Arundel Street – Manchester

DESIGN & ACCESS STATEMENT ADDENDUM | APRIL 2022

This Design and Access Statement Addendum by SimpsonHaugh has been prepared in support of proposed amendments to the approved planning application (ref. 123261/FO/2019) for the following:

Level 00 - Proposed Amendments

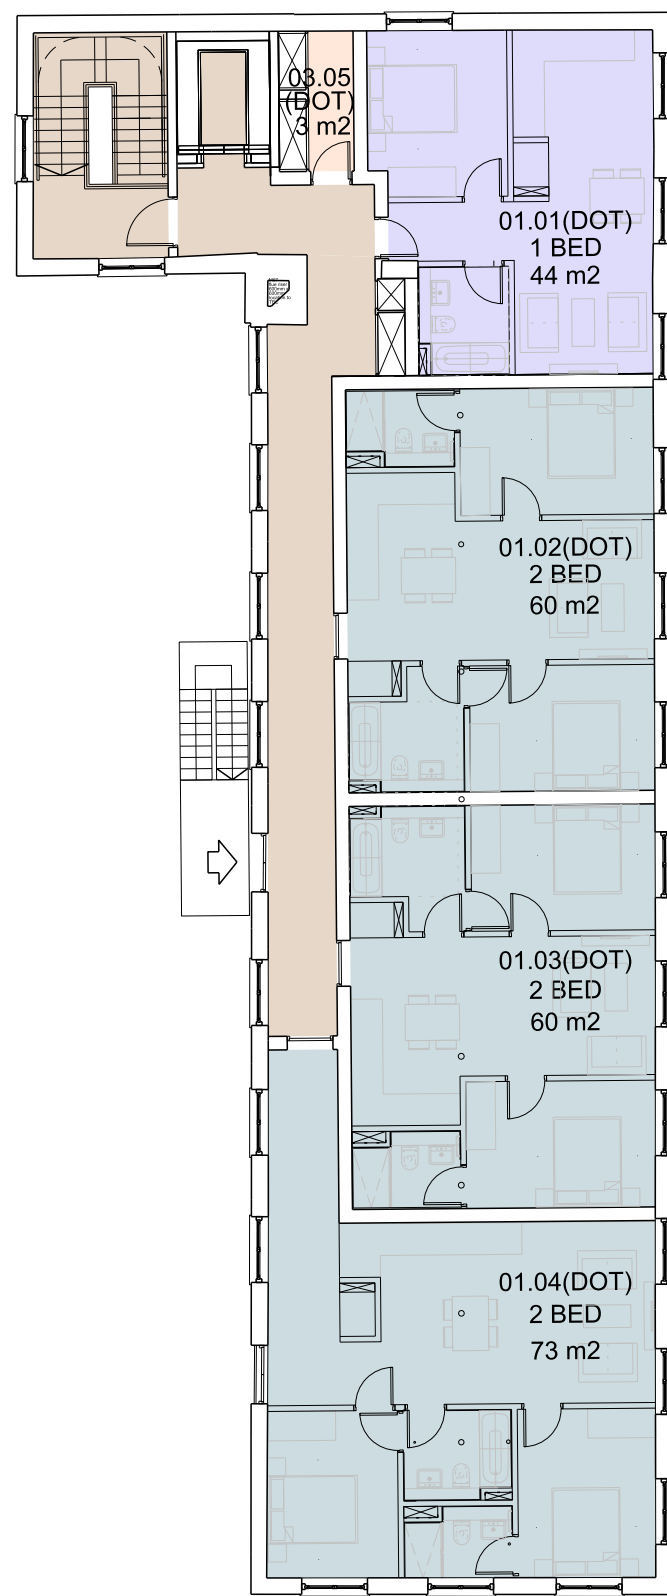
The proposed ground floor comprises an open plan gym occupying the main space, with a new lift and stair core, plant and accessible washroom within the northeast wing. The entrance to the communal core is situated on Arundel Street.

- 01 INTERNAL SPACES AND SERVICES ARRANGEMENTS AMENDED TO ACCOMMODATE NEW INTERNAL FUNCTIONS
- 02 COMMUNAL ENTRANCE AND CIRCULATION
- 03 CORE ARRANGEMENT REVISED TO SUIT REVISED INTERNAL FUNCTIONS
- 04 ENLARGED EXTERNAL METAL MEANS OF ESCAPE STAIR
- 05 SHARED ACCESSIBLE SHOWER AND WC CHANGING FACILITIES FOR GYM
- 06 REFUSE STORE SERVING DOT GYM AND COMMERCIAL SPACES HAVE BEEN RELOCATED TO SHARED PROVISION WITHIN BUILDINGS 1 & 2
- 07 REAR DOOR FACILITATE ACCESS TO SHARED BIN STORE VIA COURTYARD
- 08 GYM STUDIO
- 09 DEDICATED ACCESS AND EGRESS TO GYM STUDIO

Level 1 - Proposed Amendments

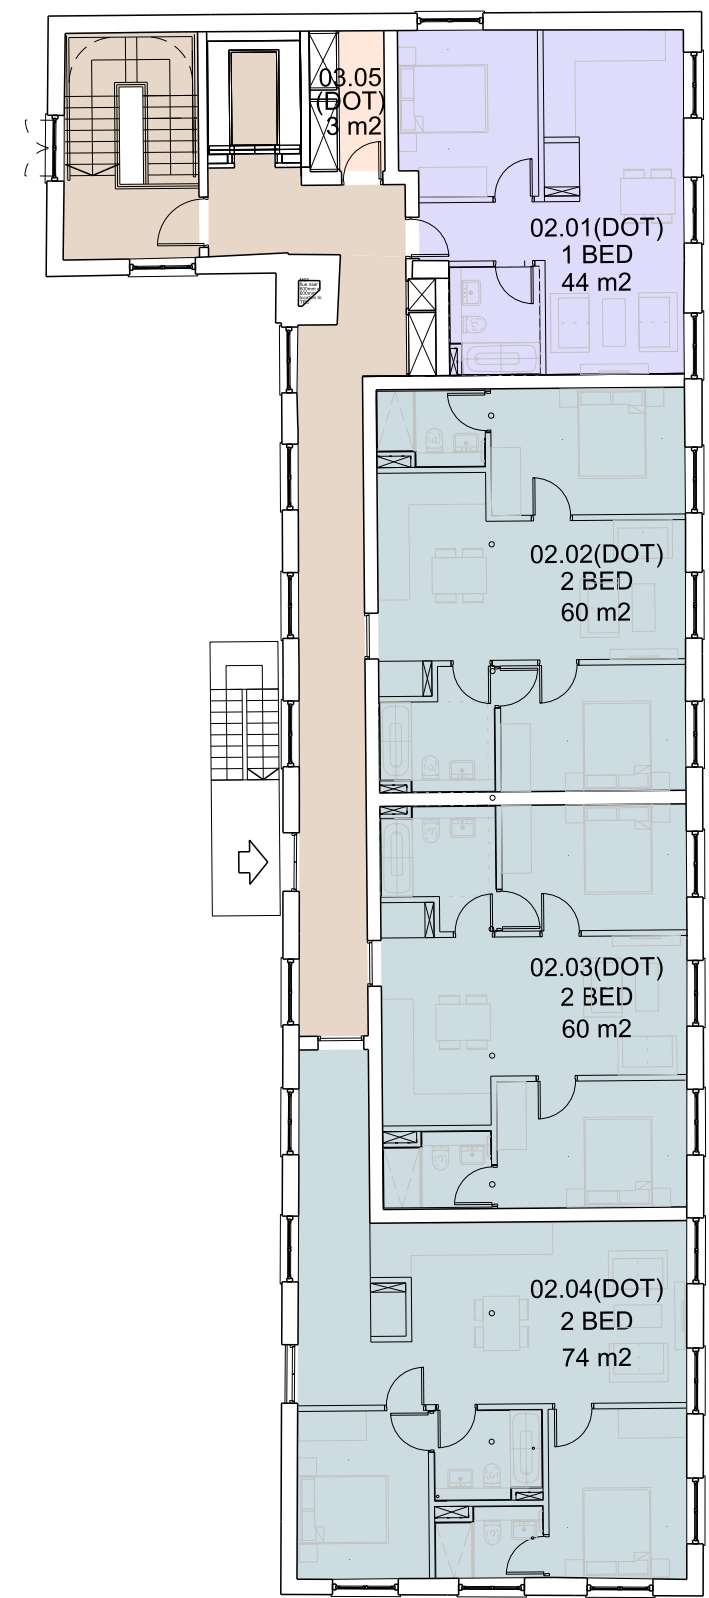
A second open-plan gym space is proposed at Level 1, supported by changing provision and treatment rooms adjacent to and within the northeast wing.

- 01 INTERNAL SPACES AND SERVICES ARRANGEMENTS AMENDED TO ACCOMMODATE NEW INTERNAL FUNCTIONS
- 02 COMMUNAL CIRCULATION
- 03 CORE ARRANGEMENT REVISED TO SUIT REVISED INTERNAL FUNCTIONS
- 04 ENLARGED EXTERNAL METAL MEANS OF ESCAPE STAIR
- 05 CHANGING FACILITIES FOR GYM
- 06 PHYSIOTHERAPY TREATMENT ROOM FOR GYM
- 07 GYM STUDIO
- 08 NEW WINDOW OPENING PROPOSED IN APPROVED SCHEME TO BE OMITTED

Levels 2-3 - Proposed Amendments

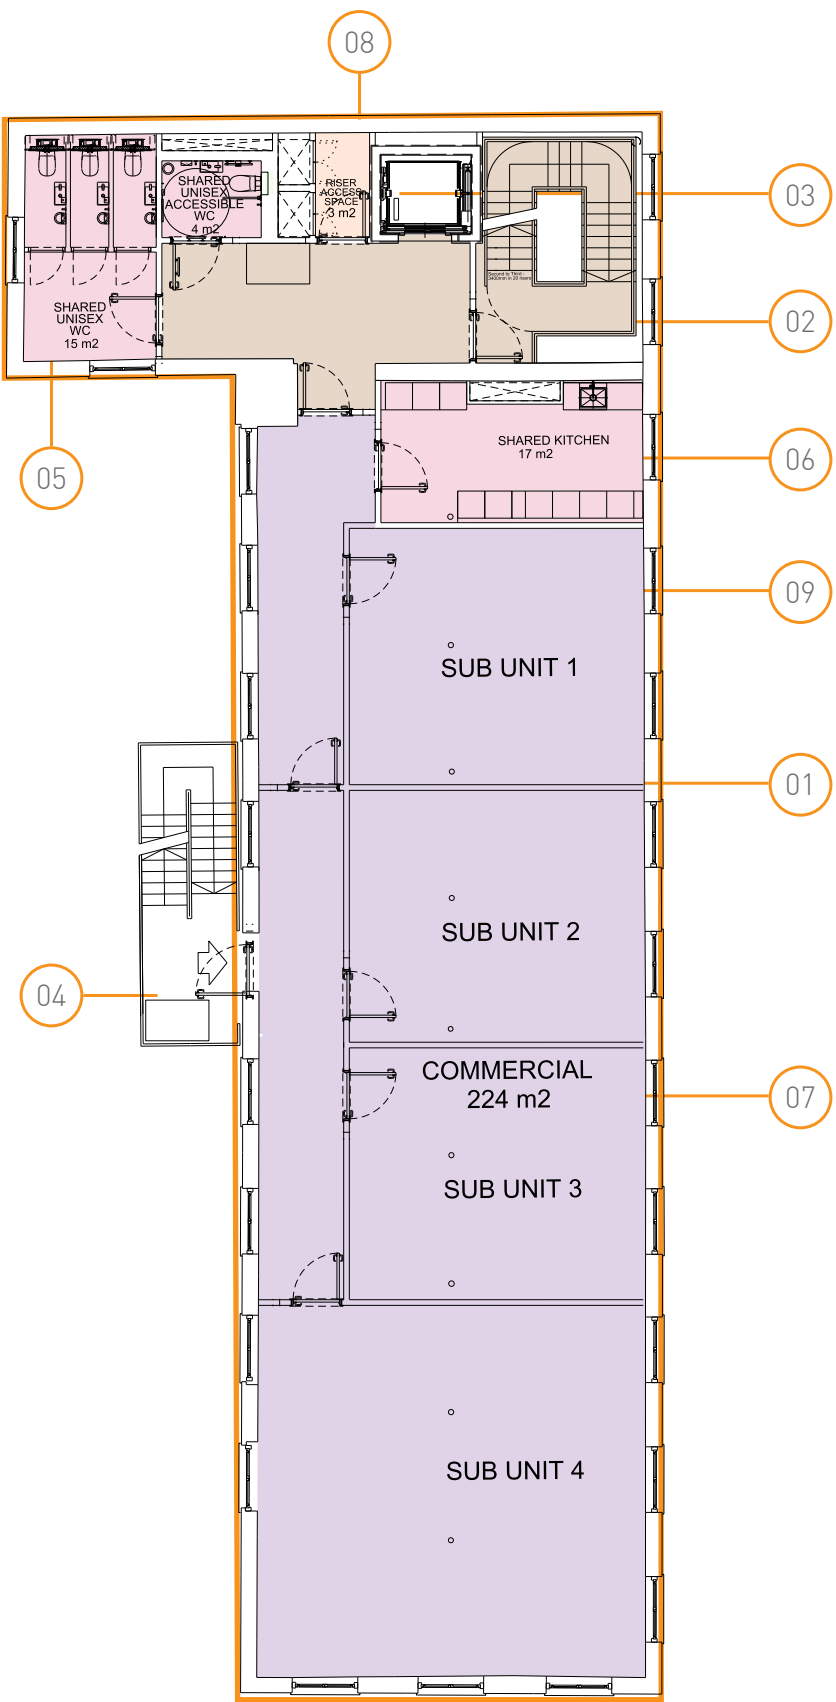
Levels 2 and 3 are proposed to be amended to commercial use, with the majority of the floor plates subdivided into individual units, supported by communal washrooms and shared kitchen space adjacent to and within the northeast wing

- 01 INTERNAL SPACES AND SERVICES ARRANGEMENTS AMENDED TO ACCOMMODATE NEW INTERNAL FUNCTIONS
- 02 COMMUNAL CIRCULATION
- 03 CORE ARRANGEMENT REVISED TO SUIT REVISED INTERNAL FUNCTIONS
- 04 ENLARGED EXTERNAL METAL MEANS OF ESCAPE STAIR
- 05 COMMUNAL WC PROVISION
- 06 COMMUNAL KITCHEN FACILITIES
- 07 COMMERCIAL SPACE WITH INDICATIVE SUBDIVISION
- 08 NEW WINDOW OPENING PROPOSED IN APPROVED SCHEME TO BE OMITTED

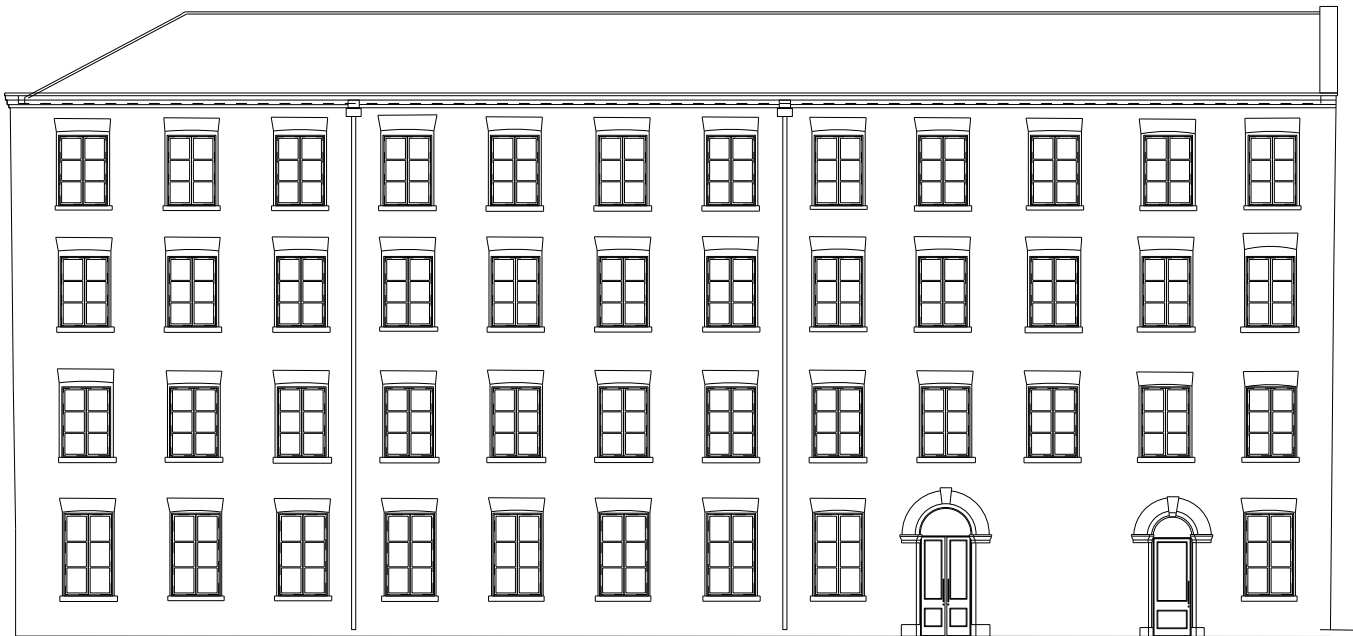
Following the proposed amendments to the facade modules outlined in Section 2.4.1 and 2.4.2, it is proposed that amendments are made to the building outline enclosing the central courtyard. These are illustrated in the adjacent image.

The outline of the approved scheme is illustrated by the blue dotted line and the proposed amendments scheme retains the outline on the outward facing facades.

On Building 1, it is proposed that the northwest facing facade line moves inwards by 225mm (one brick length), and the southwest facing moves outwards by 225mm (one brick length).

On Building 2, it is proposed that the southeast facing facade line moves inwards by 225mm (one brick length). The projecting corner of the tower massing remains as the approved scheme.

- 01 APPROVED SCHEME BUILDING OUTLINE (BLUE DASH)
- 02 PROPOSED AMENDED BUILDING OUTLINE MOVED INWARDS BY 225MM
- 03 PROPOSED AMENDED BUILDING OUTLINE MOVED OUTWARD BY 225MM

East Elevation - Proposed Amendments

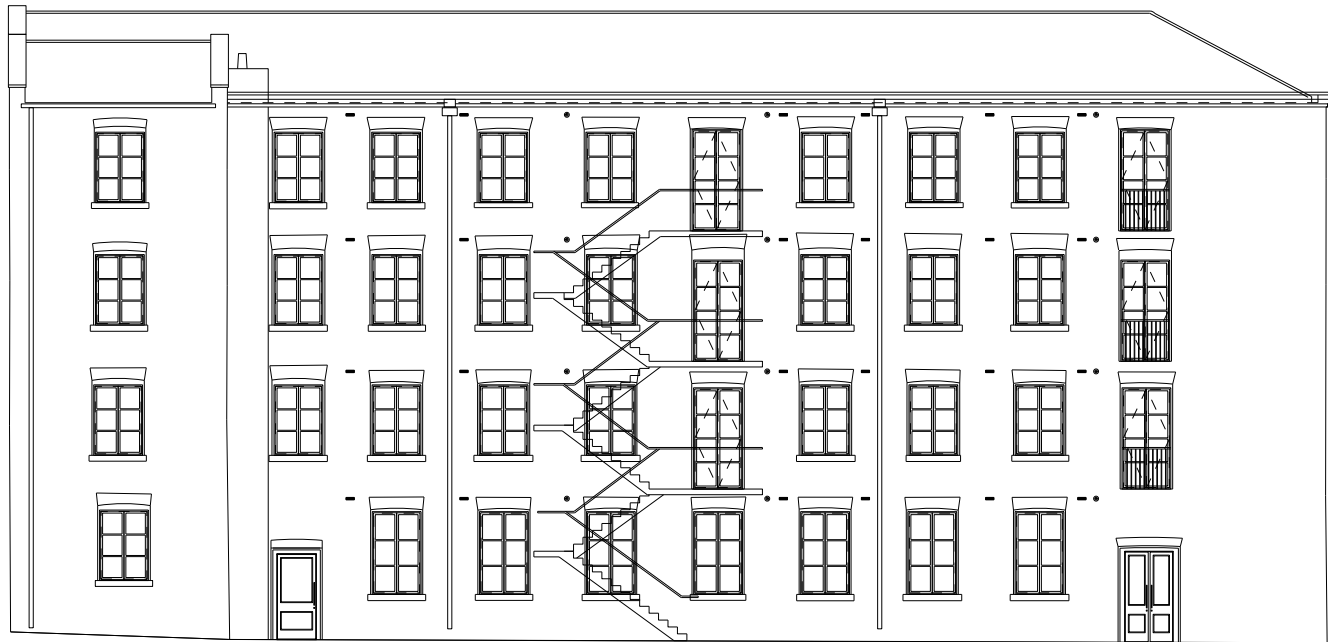
The approved new window openings in the east facade will be omitted to suit the internal arrangement of the communal core and to avoid any views into the adjacent residential units within Building 2.

Service penetrations proposed in the approved scheme will be omitted to suit the proposed change of use.

North Elevation - Proposed Amendments

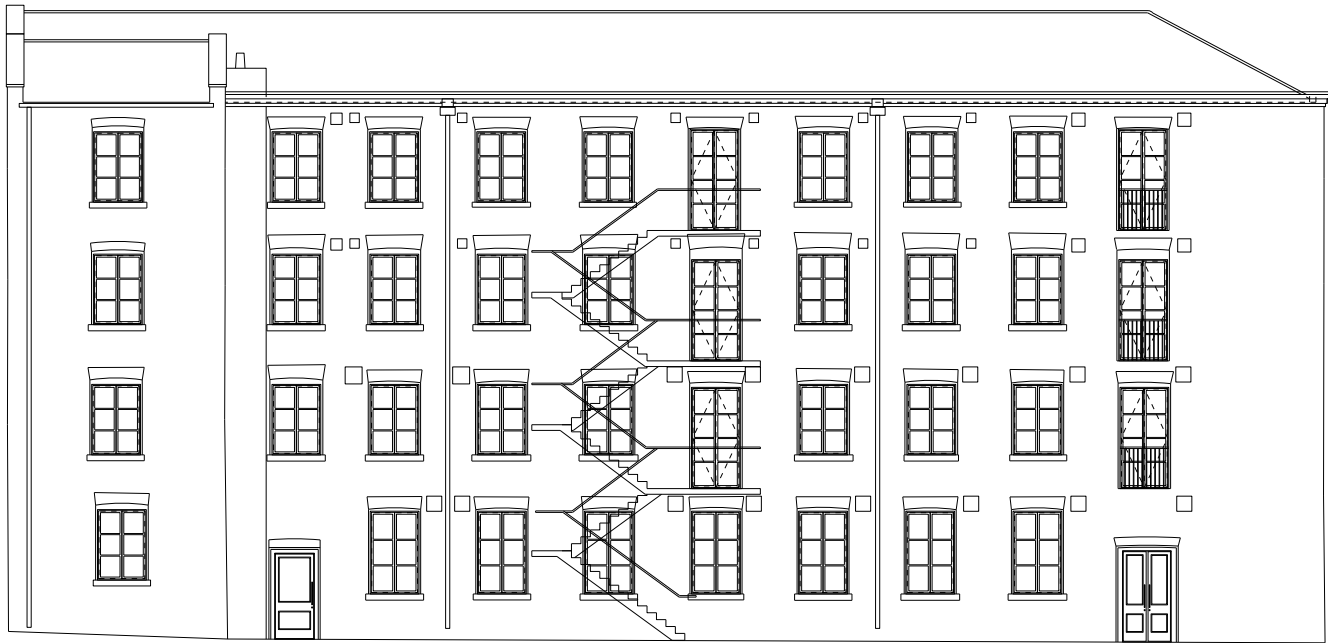
The proposed amendments retain the new windows proposed in the approved scheme.

The provision of service penetrations will be amended to suit the proposed change of use.

The replacement external metal staircase providing a secondary means of escape for Levels 01, 02 and 03 will be enlarged in plan to suit the proposed change of use from residential to leisure/commercial.
